ADDENDUM NO. 2

DATE OF ISSUANCE: March 21, 2023

PROJECT: 2023 Henryville Flooring Replacement
Phase 2 & Cafeteria Expansion
213 N. Ferguson. St.
Henryville, IN 47126

ARCHITECT'S PROJECT NO.: 21-47.007

SHEET NUMBER
C101
202147.007

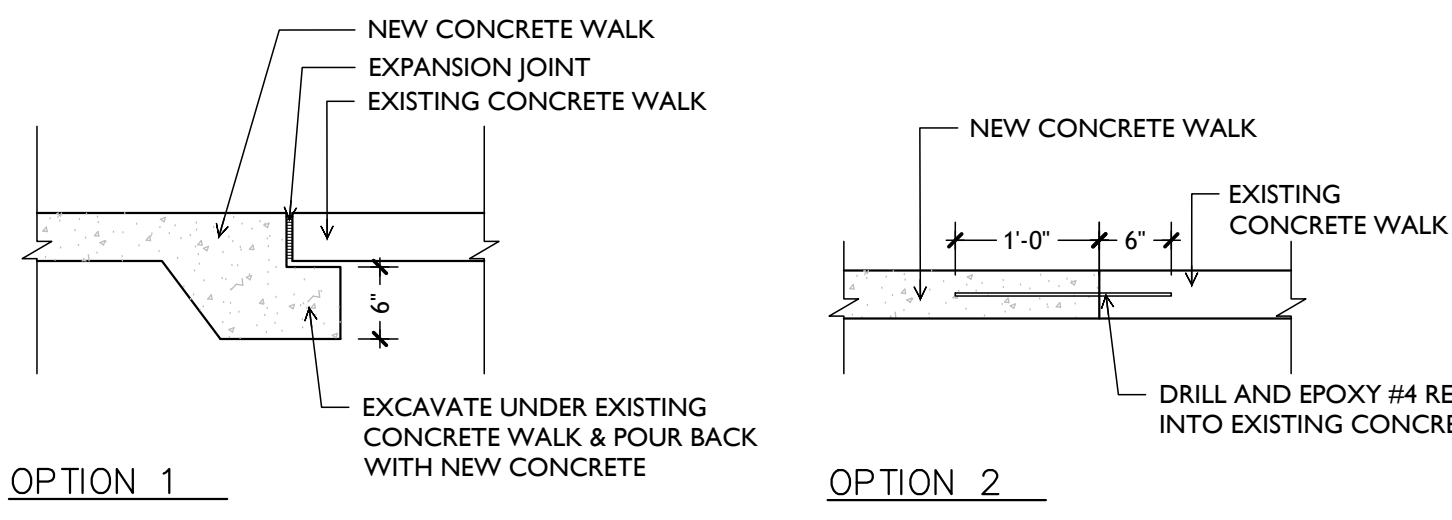
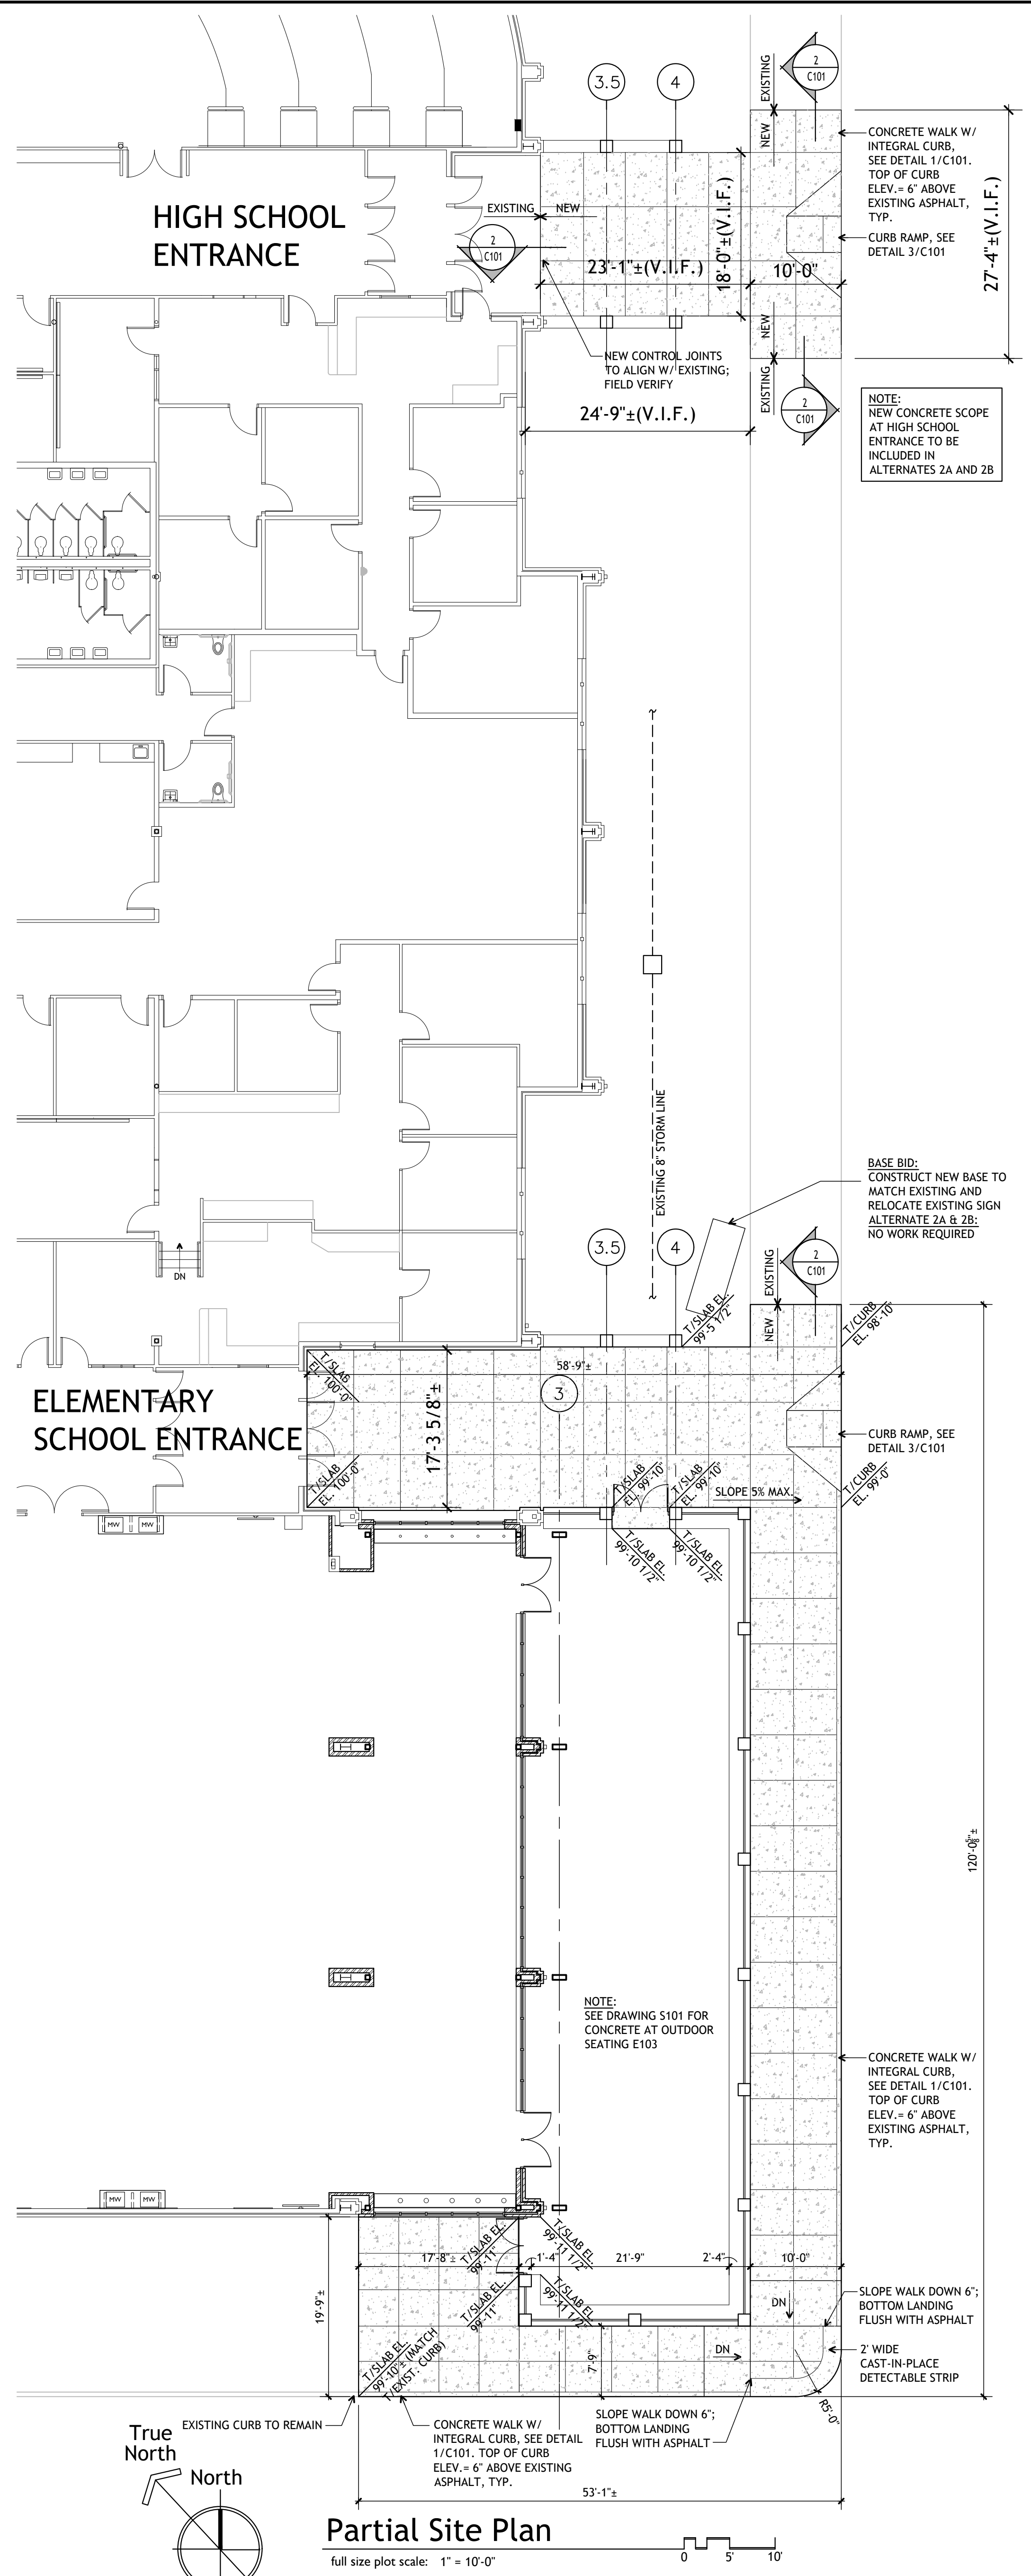
ADD-1 Item No. D-1 - Site Plan

Refer to Sheet(s): C101

Add attached Drawing in its entirety; drawing includes site plan and details.

ADD-1 Item No. D-2 - Accessibility Ramp Details

Delete Accessibility Ramp Details in their entirety; refer to attached Drawing C101 for replacement details.
